Date	Rev.	Status or Amendment
28/08/17	A	Issue for DA Amendment

Pursuant to section 197 of the *Planning and Development Act 2007*, approval is sought to amend development approval No. 201630289 dated 13/12/2016 as described at **Attachment A.**

Project: Canberra Labor Club Belconnen Hotel
Blocks: 8+9 | Section: 48 | Division: Belconnen
Drawing Title: Ground Floor Plan
Job No.: 16_35 | Drawing No.: DA-A101 | Scale: 1 : 100@A1 | Rev.: F

Drawing Title
West Elevation

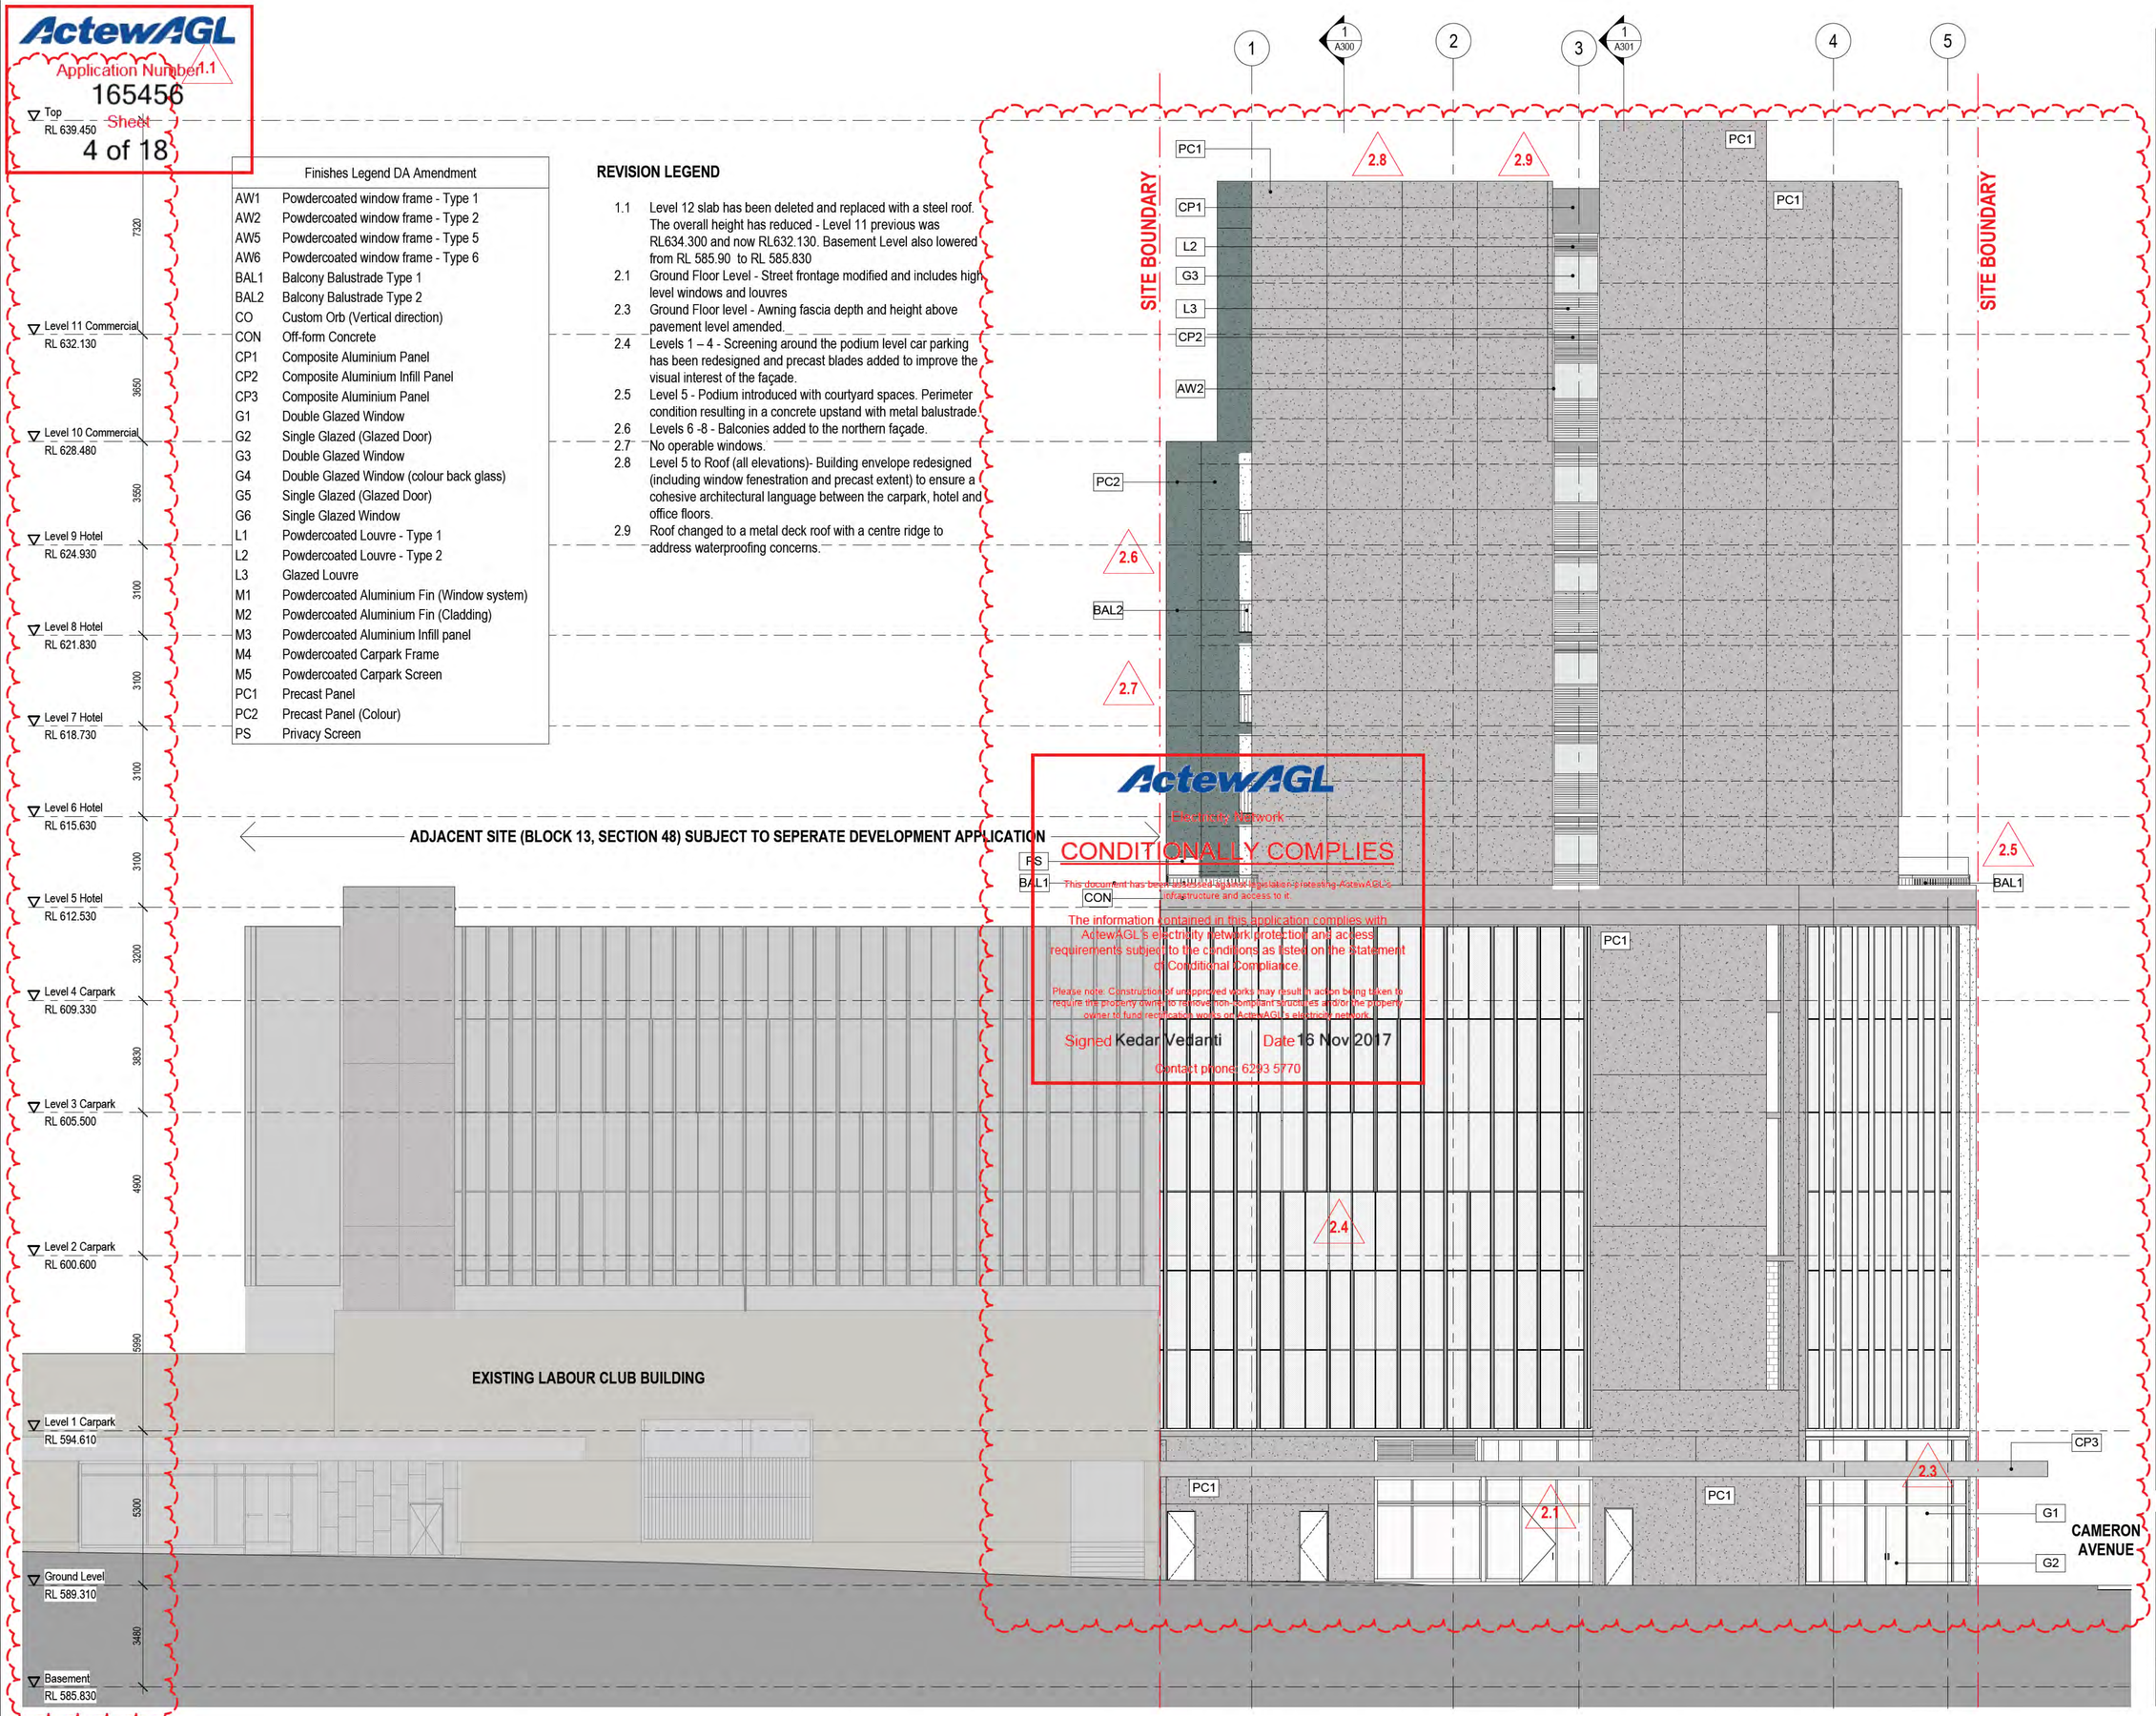
2.1 Ground Floor Level - Street frontage modified and includes high level windows and louvres
2.3 Ground Floor level - Awning fascia depth and height above pavement level amended.

2.4 Levels 1 – 4 - Screening around the podium level car parking has been redesigned and precast blades added to improve the visual interest of the façade.

2.5 Level 5 - Podium introduced with courtyard spaces. Perimeter condition resulting in a concrete upstand with metal balustrade.
2.6 Levels 6 -8 - Balconies added to the northern façade.

2.7 No operable windows.
2.8 Level 5 to Roof (all elevations)- Building envelope redesigned (including window fenestration and precast extent) to ensure a cohesive architectural language between the carpark, hotel and office floors.

2.9 Roof changed to a metal deck roof with a centre ridge to address waterproofing concerns.

Drawing Title: Basement Floor Plan

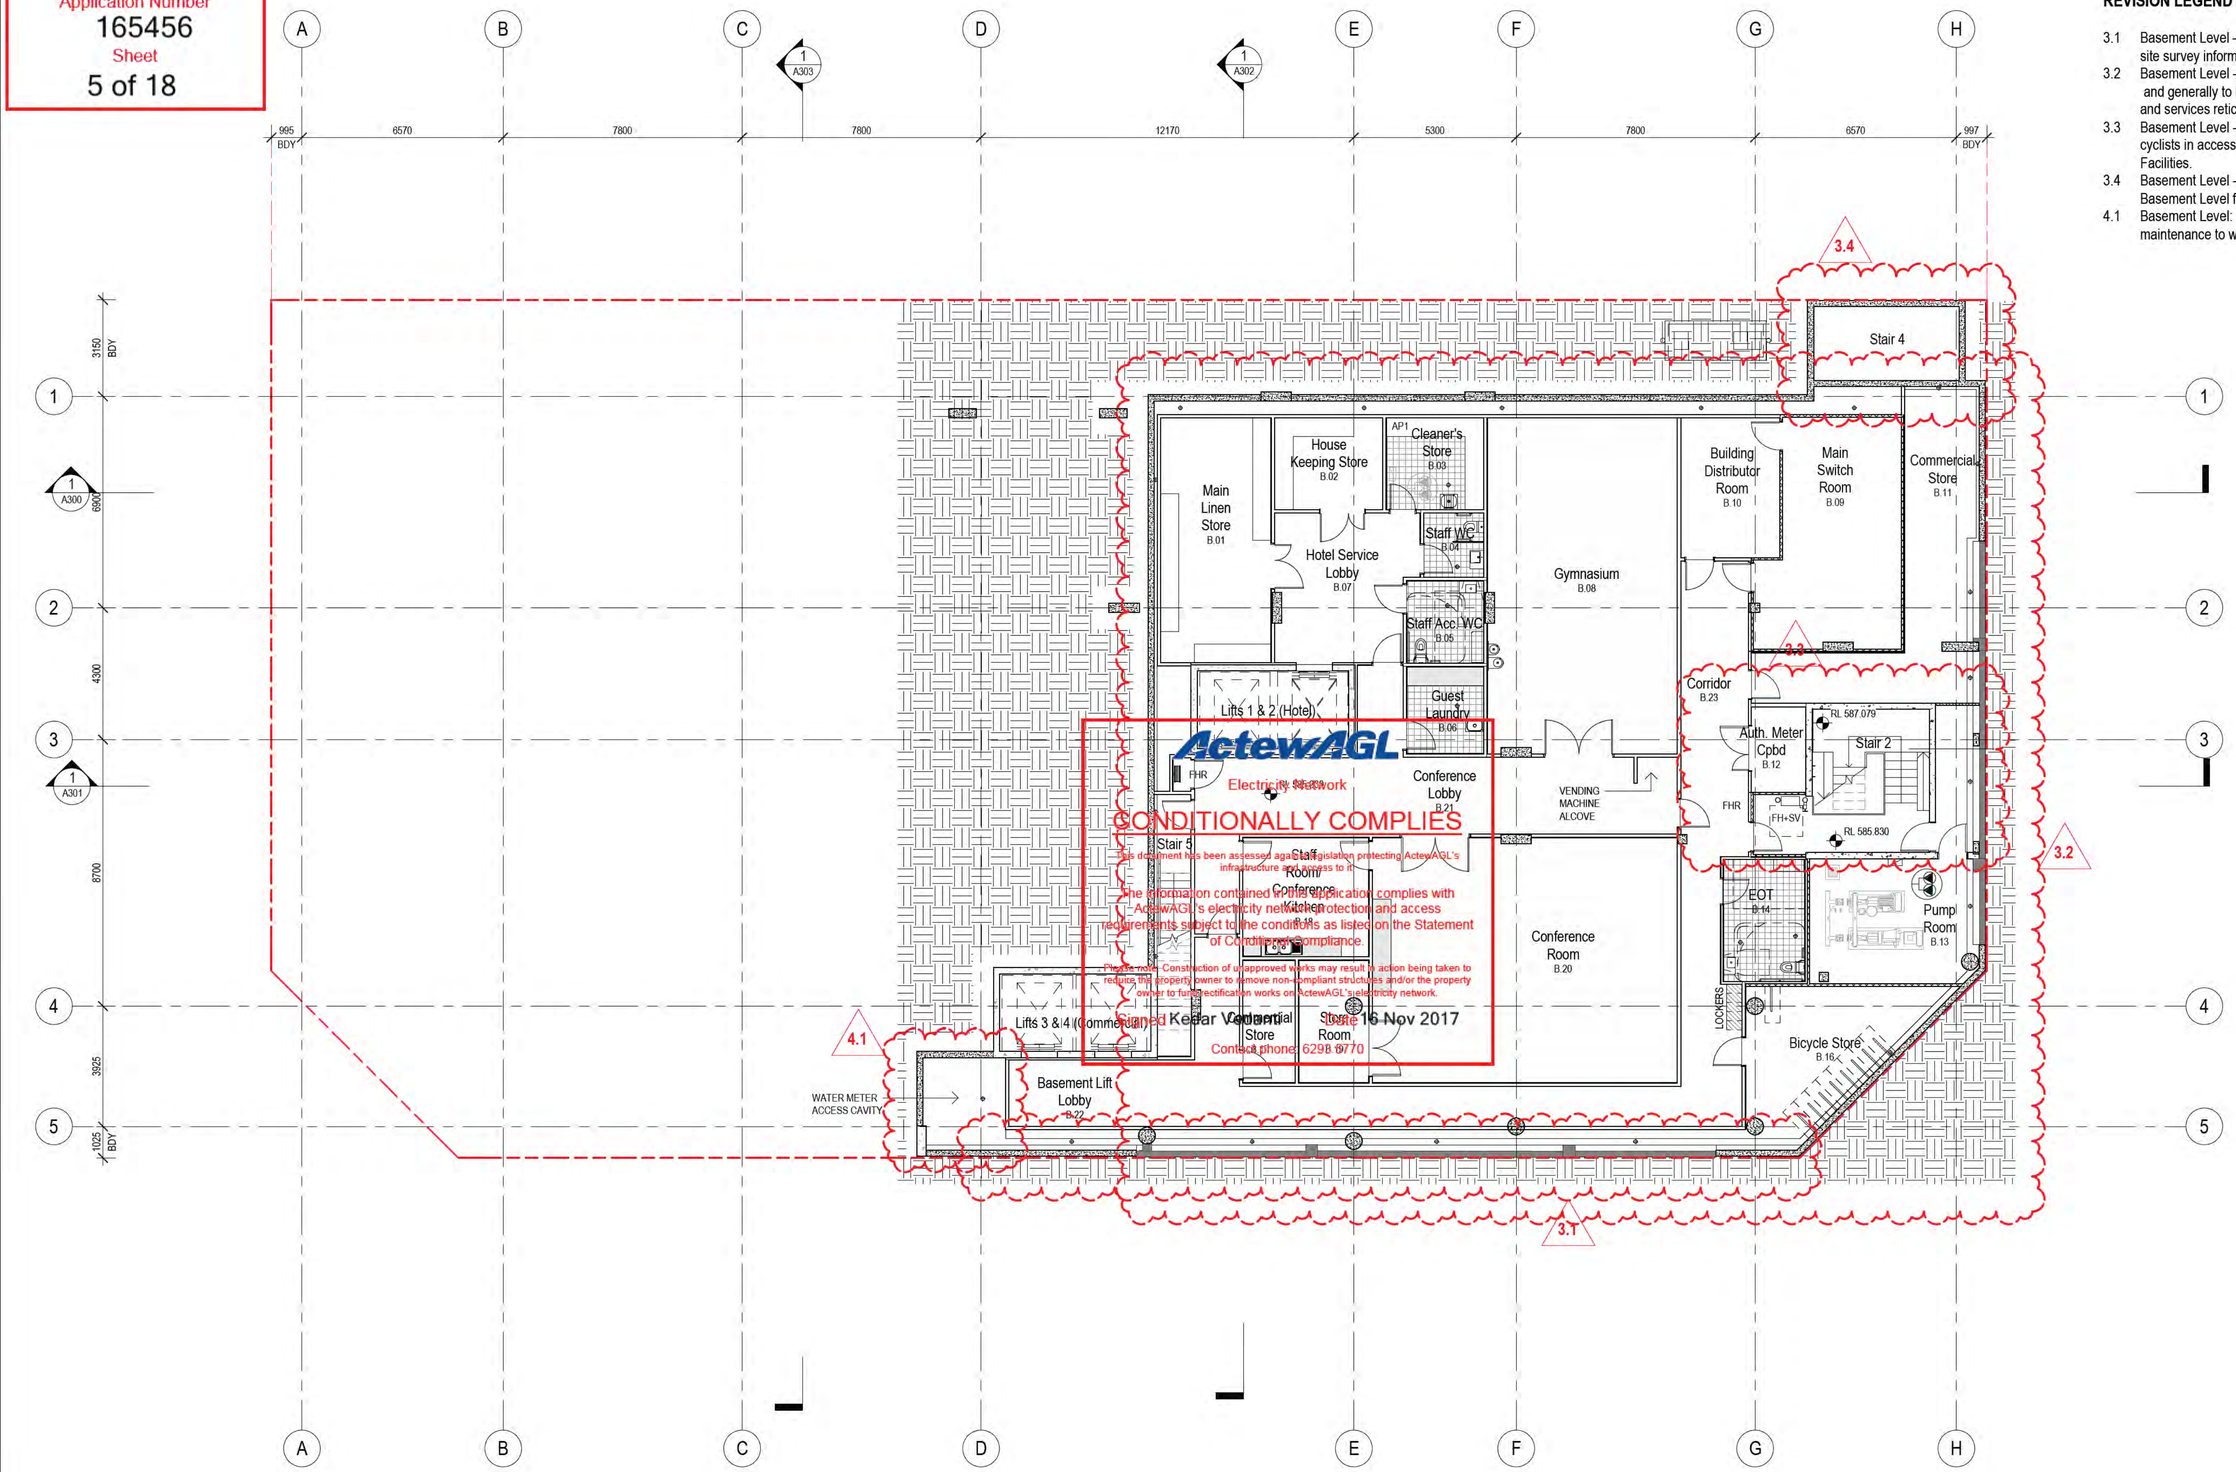
3.1 Basement Level – Existing basement wall locations verified with site survey information.
3.2 Basement Level - replanned to include end of trip cycling facilities and generally to improve the functionality and amenity of the space and services reticulation.
3.3 Basement Level - Stair No. 2 added with bike ramp to assist cyclists in accessing the Bicycle Store and End of Trip Cycling Facilities.
3.4 Basement Level - The base of Stair No. 4 has been extended to the Basement Level for structural stability only.
4.1 Basement Level: demolition extent increased to ensure authority maintenance to water meter from below.

Drawing Title: Level 2 Carpark South Floor Plan

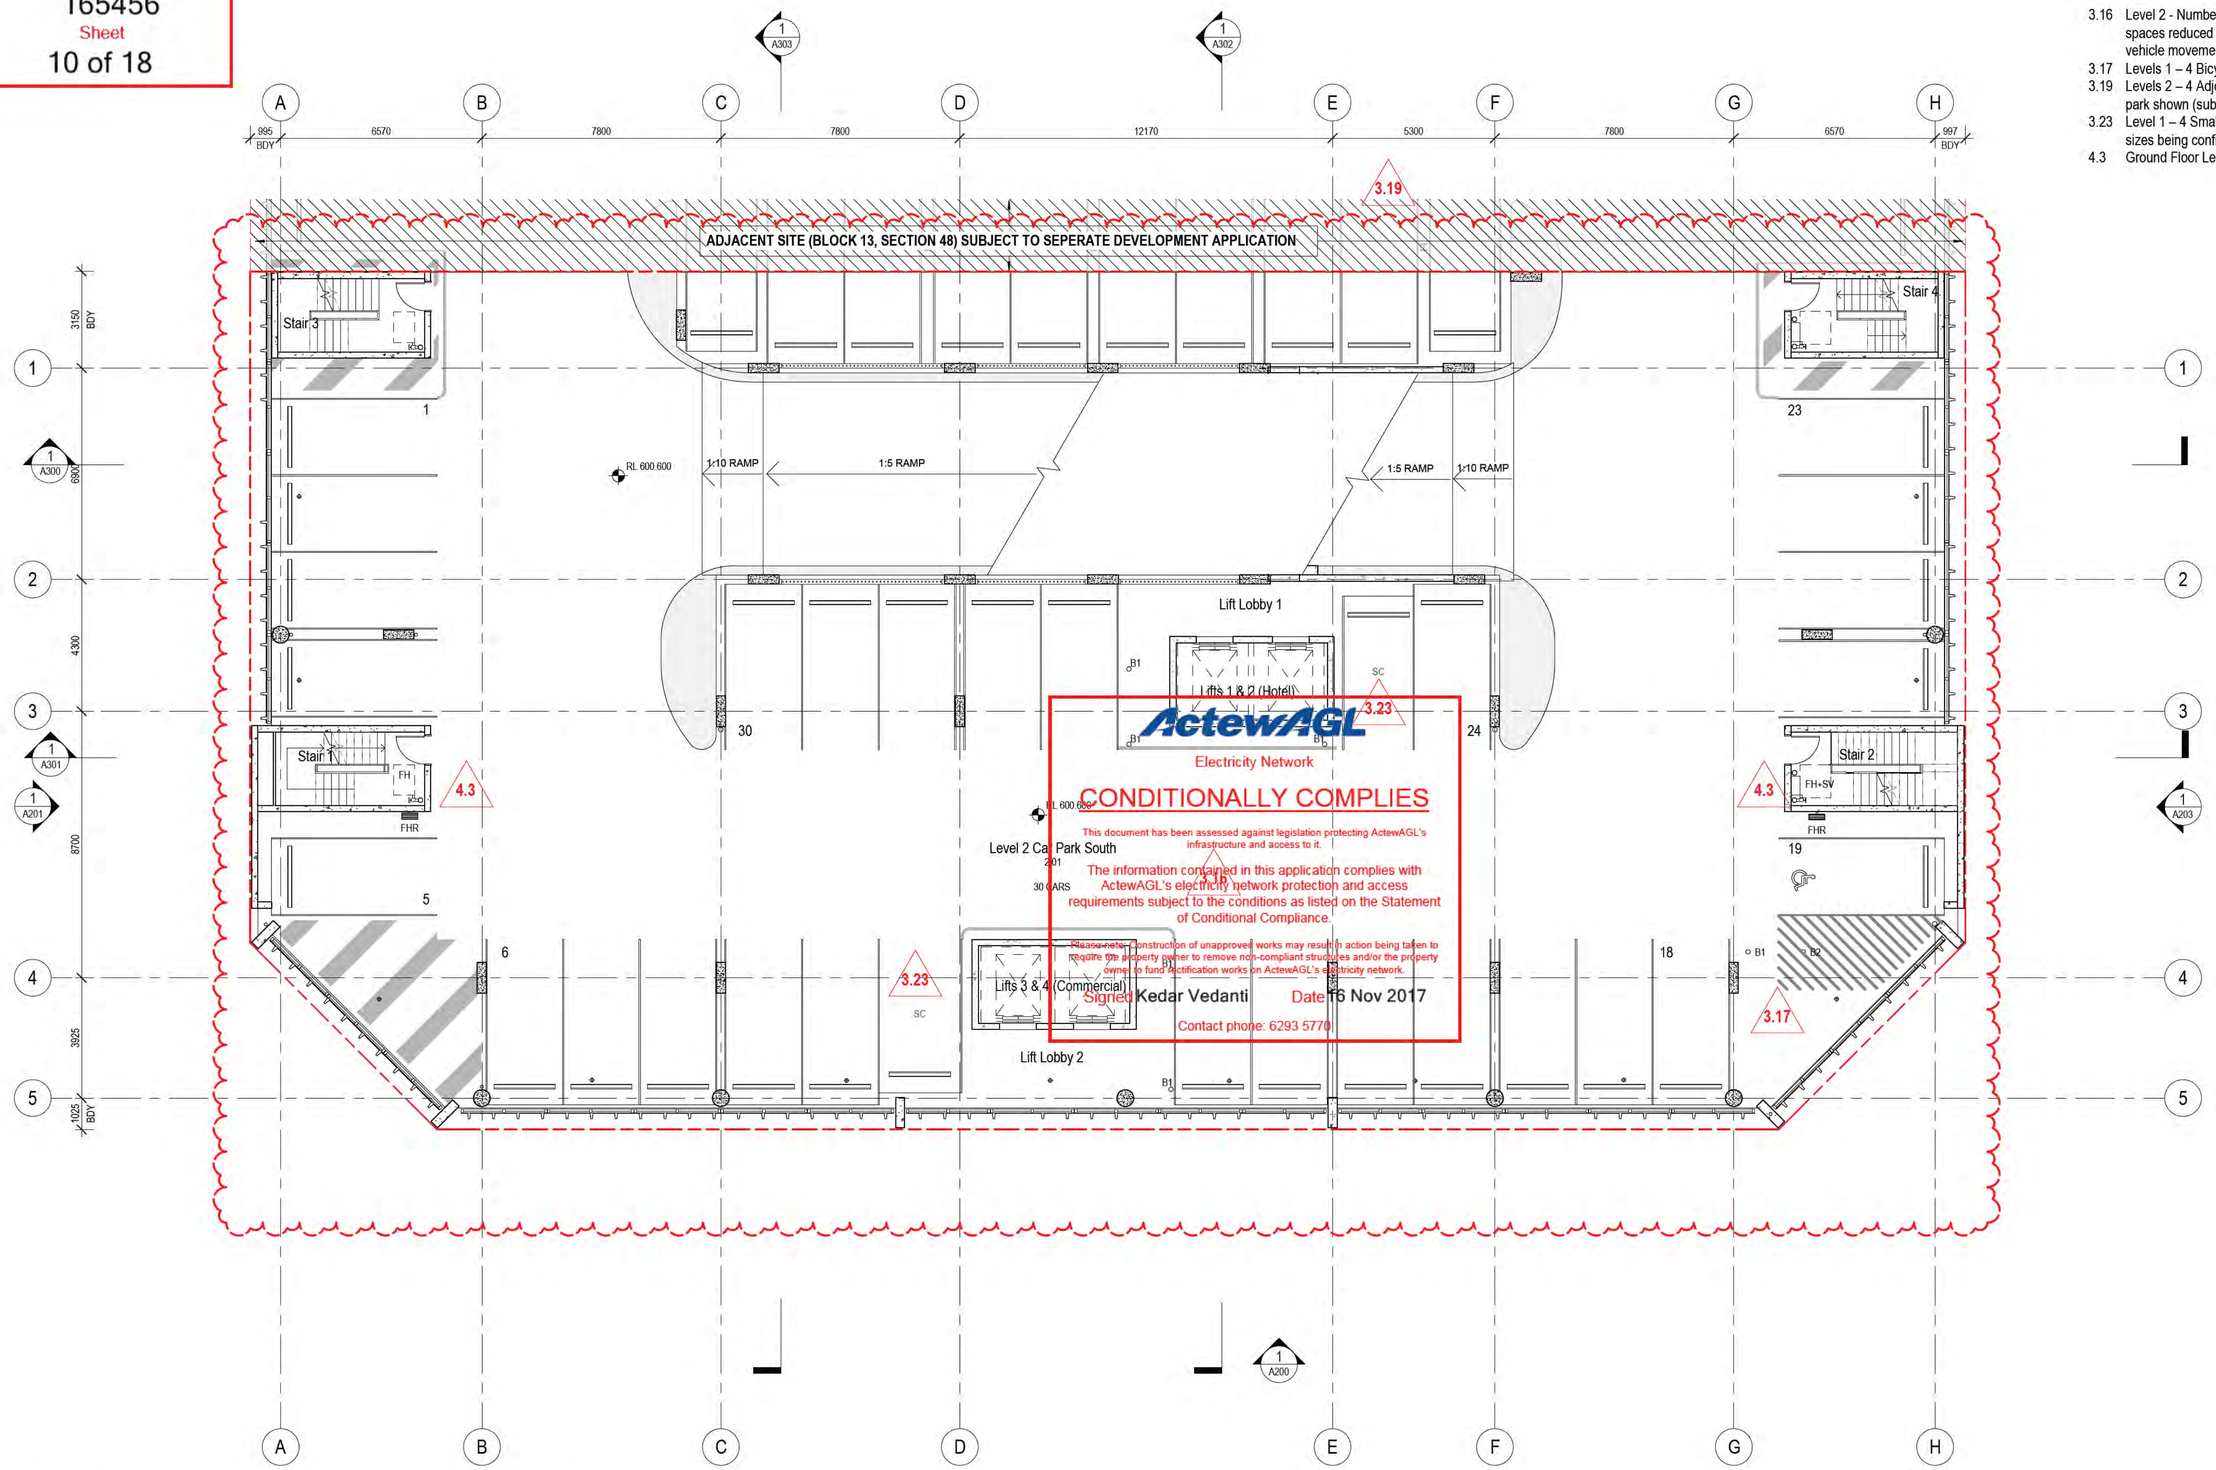
3.16 Level 2 - Number of spaces reduced to 30. Number of disabled spaces reduced to 1. Carpark numbers reduced to improve vehicle movement and turning manoeuvres.
3.17 Levels 1 – 4 Bicycle Parking relocated to the Basement Level.
3.19 Levels 2 – 4 Adjoining Canberra Labor Club podium level car park shown (subject to separate DA submission).
3.23 Level 1 – 4 Small car spaces (9 total) introduced due to lift shaft sizes being confirmed and adjustment to stair 2 on Level 4.
4.3 Ground Floor Level and Levels 1 - 3 – Stair Nos. 1 - 2 added.
